MEETING NOTES

Project Name: Granite Street 30% Design		
Meeting Location:	Frisco Community Center - 110 3rd Avenue, Frisco, CO 80443	
Date:	Wednesday, June 14, 2023	
Time:	2:30 pm – 3:30 pm, 4:00 pm – 6:00 pm	
Meeting Names:		HOA Meeting and Public Meeting
Meeting Objective:		Provide update and obtain feedback on the 30% design
Attendees:		See attached Sign-in Sheet

HOA Meeting

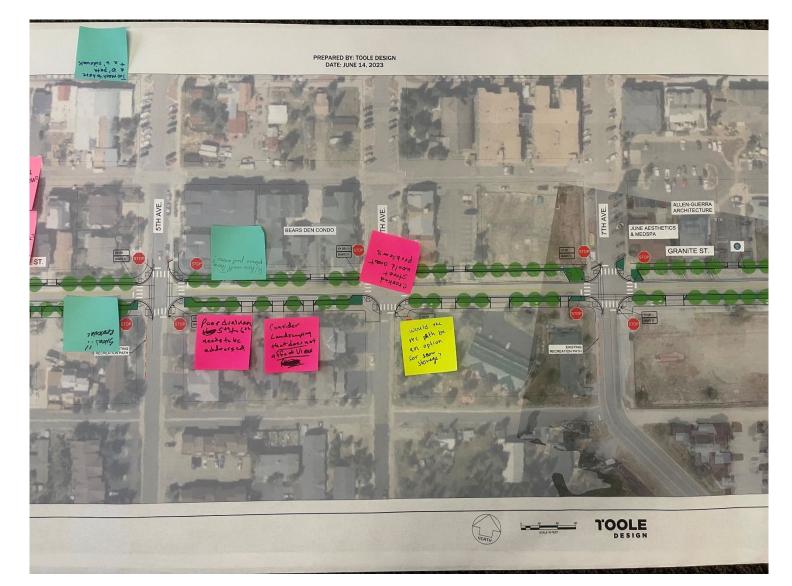
See attached images of roll plots from both meetings for specific comments and feedback.
